City of Poughkeepsie
Planning Board
Meeting Agenda

Common Council Chambers
Tuesday, February 25, 2025
6:00 PM

1. LOT#151783 SOUTH HAMILTON STREET: SITE PLAN

An application for a two-story building consisting of 29 one-bedroom units and 29 two- bedroom units. Owner/Applicant: O'Neill Group Hamilton LLC.; Consultant: Arico Associates; Grid# 6161-30-151782; Zoning District: Medium High-Density Residential (R-4); File #2023- 041

TRUCK WASH STATION

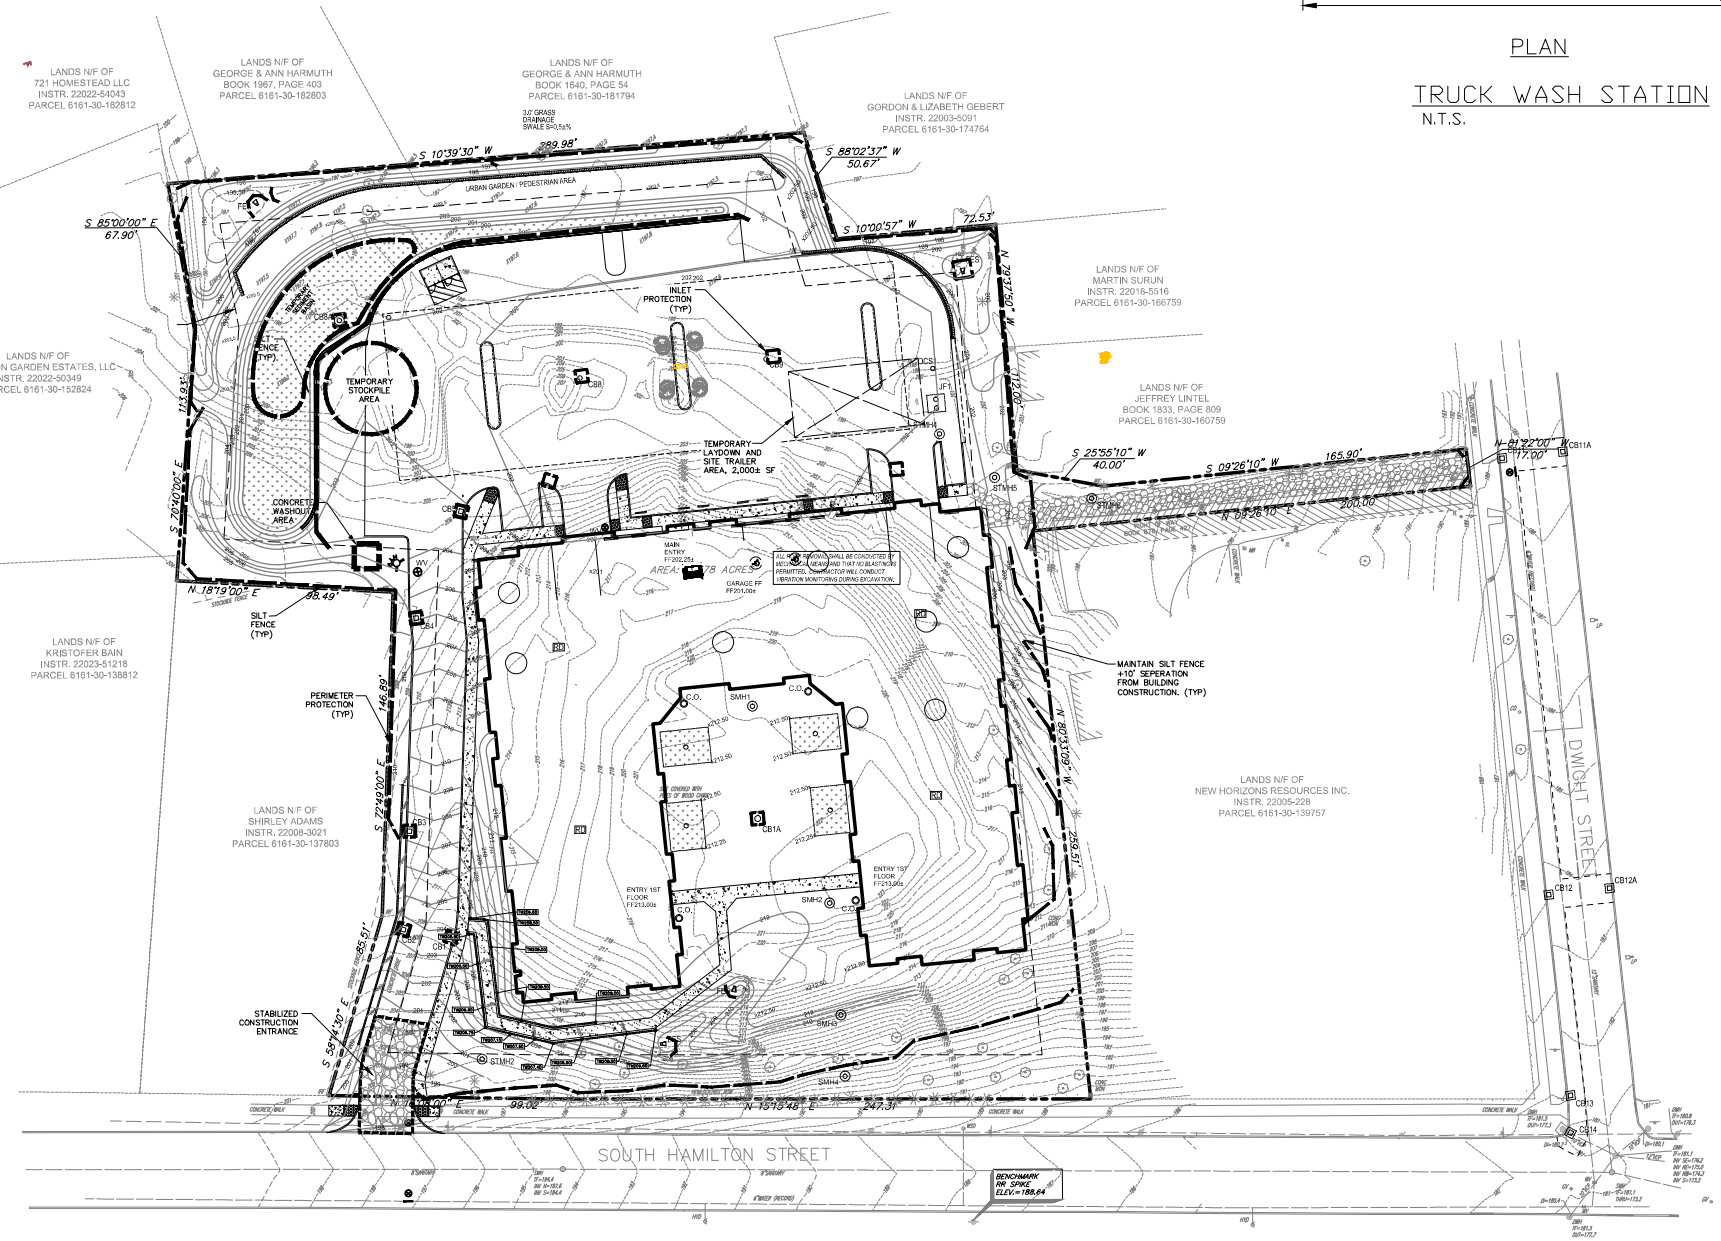
3. The additional measures noted in the Creighton Manning letter (trackout pad and truck washing) should be included in sheet S4.

DRAWING NO.
SWPPP
2.0
SHEET 1 OF 2

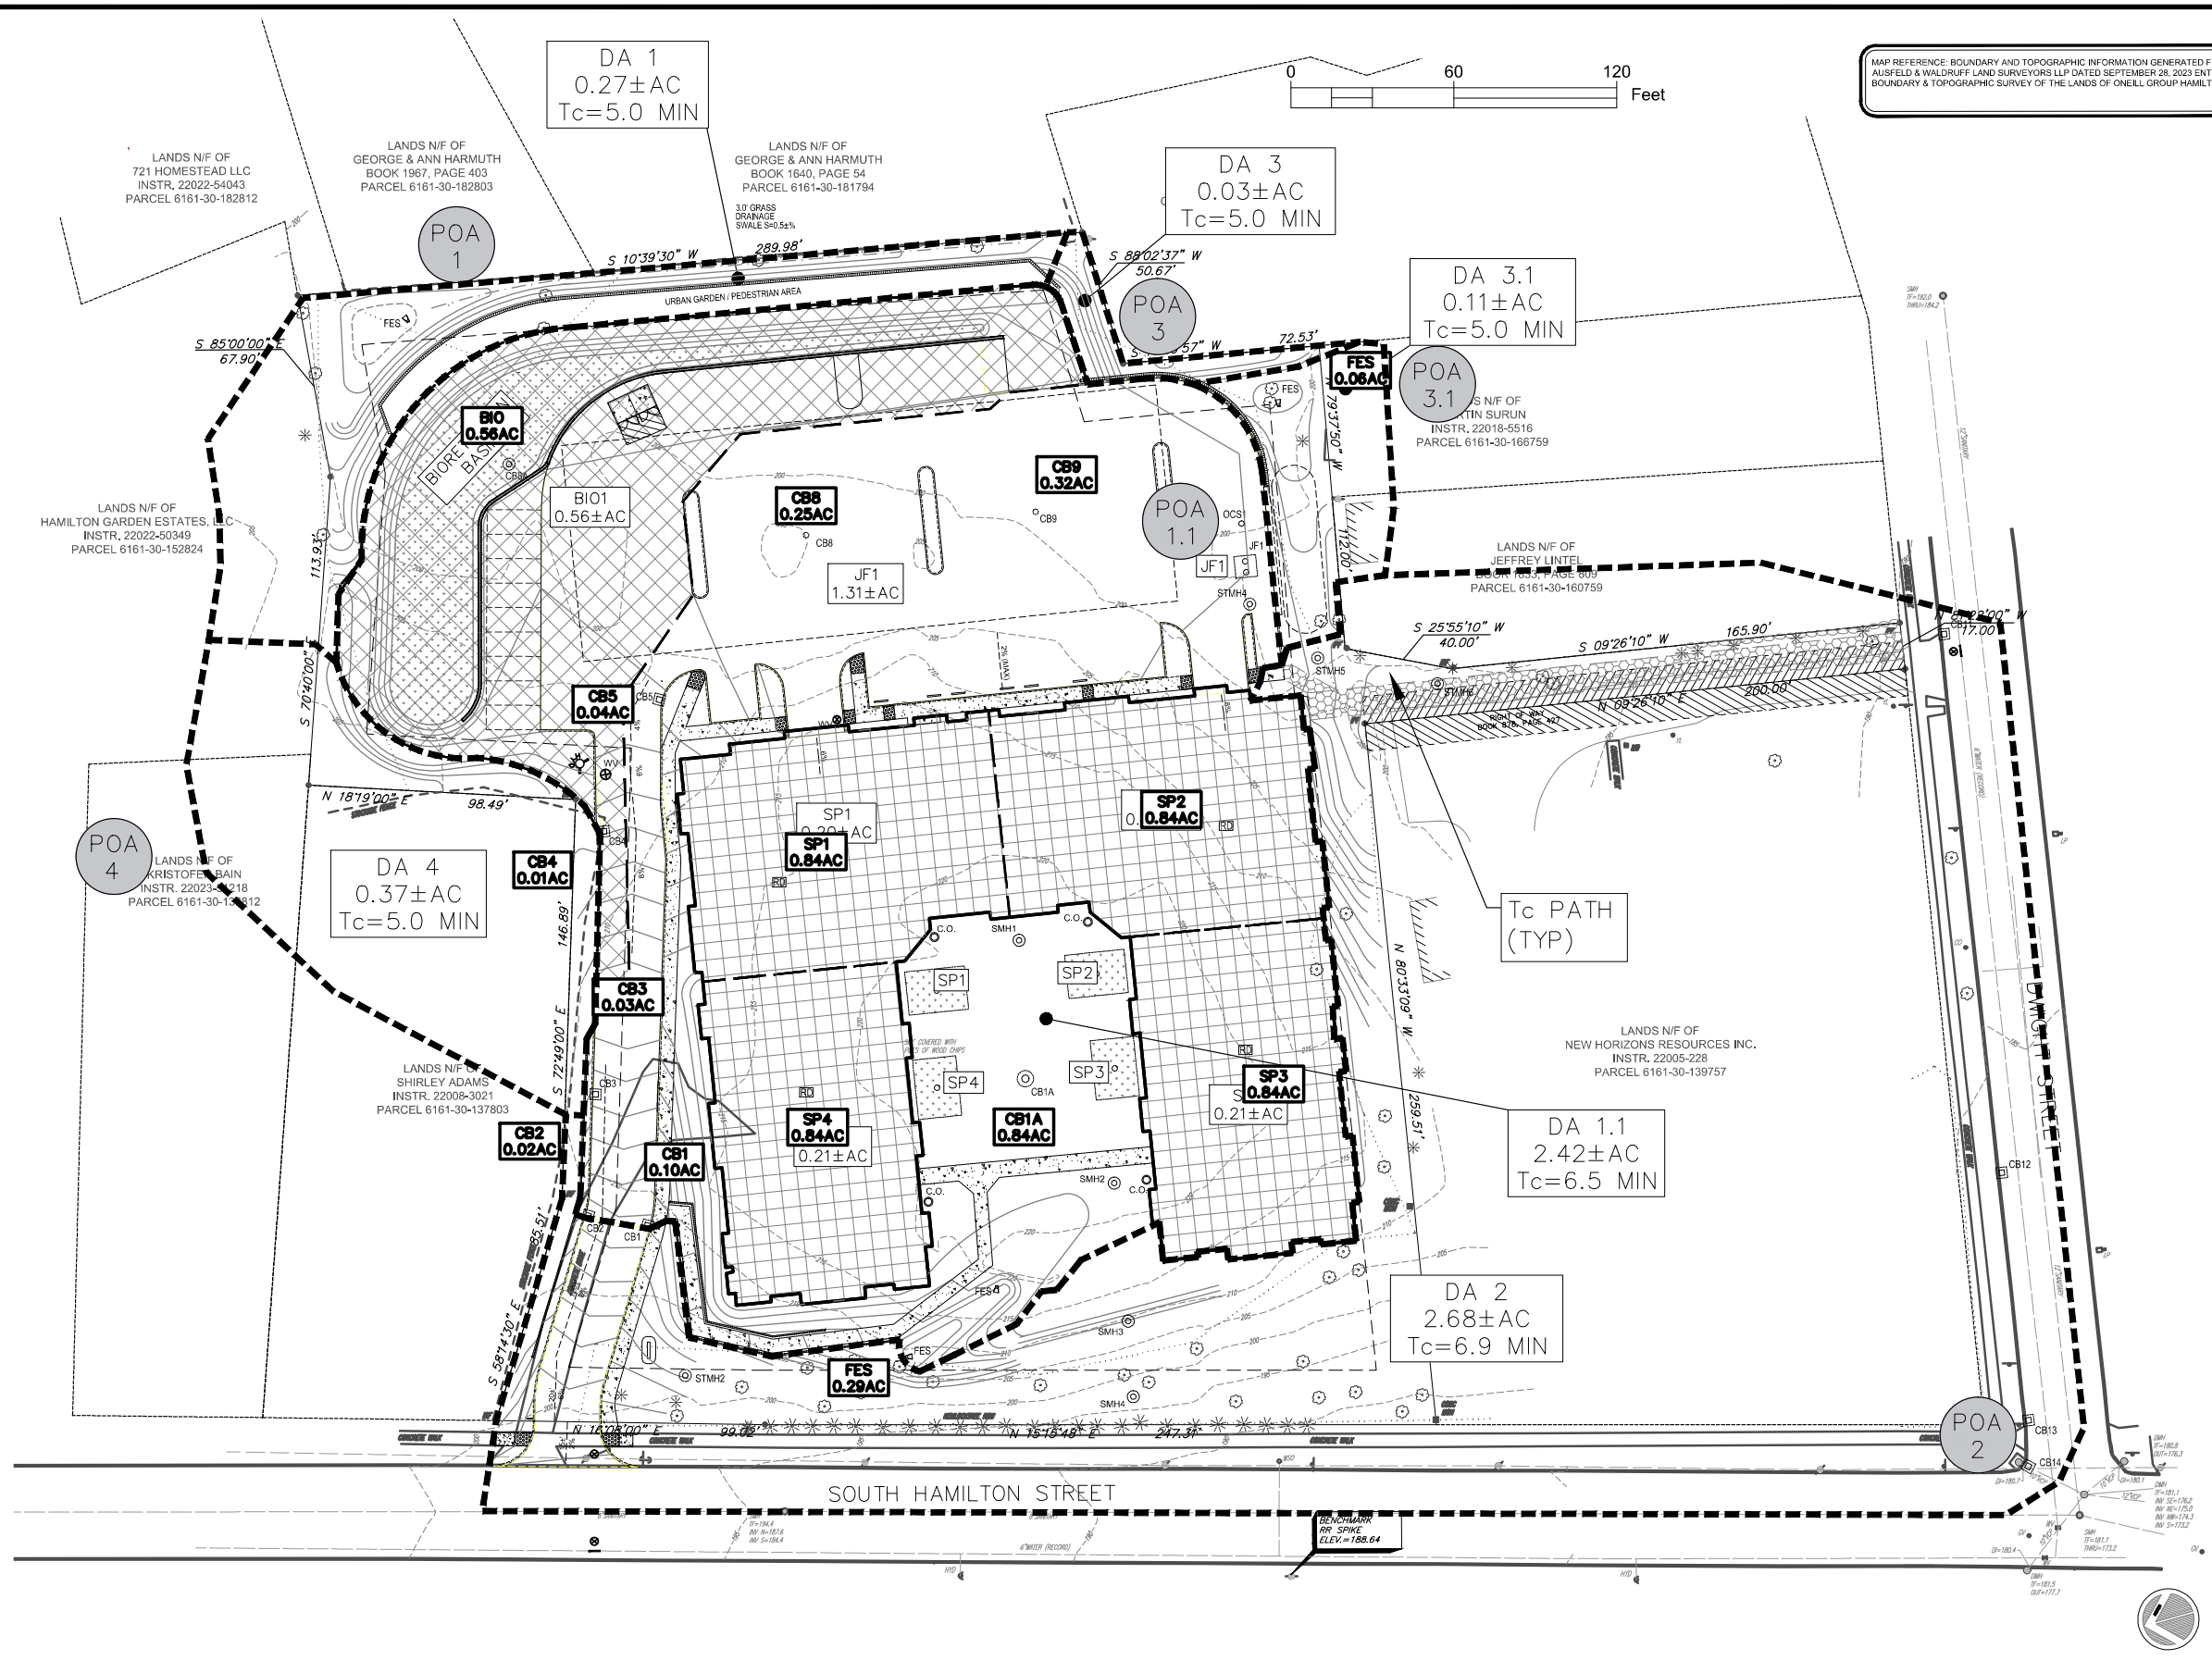
12. *4 different values of the time of concentration flow path for the post-development POA-2/DA- 2 remain. SWPPP Figures 2.0 and 2.1 show values of 10.2 min & 6.9 min, respectively, in Appendix G. A different version of figures SWPPP 2.0 & 2.1 are provided in Appendix H and show a DA-2 Tc of 16.4 min. The node summaries provided in Appendix G show a DA-2 Tc of 6.9 minutes. The HydroCAD model in Appendix H reports a DA-2 Tc of 14.4 minutes. Update the HydroCAD model and maps as needed.* **Response is still under review after discussion with the city engineering department and consultant engineer.**

12. 4 different values of the time of concentration flow path for the post-development POA-2/DA-2 remain. SWPPP Figures 2.0 and 2.1 show values of 10.2 min & 6.9 min, respectively, in Appendix G. A different version of figures SWPPP 2.0 & 2.1 are provided in Appendix H and show a DA-2 Tc of 16.4 min. The node summaries provided in Appendix G show a DA-2 Tc of 6.9 minutes. The HydroCAD model in Appendix H reports a DA-2 Tc of 14.4 minutes. Update the HydroCAD model and maps as needed.
13. The hydraulic model in Appendix H shows a minor increase in peak discharge rate to POA1+POA2 during the 10-year storm. Revise the model as needed to match or reduce the peak discharge rate in the post-development condition.
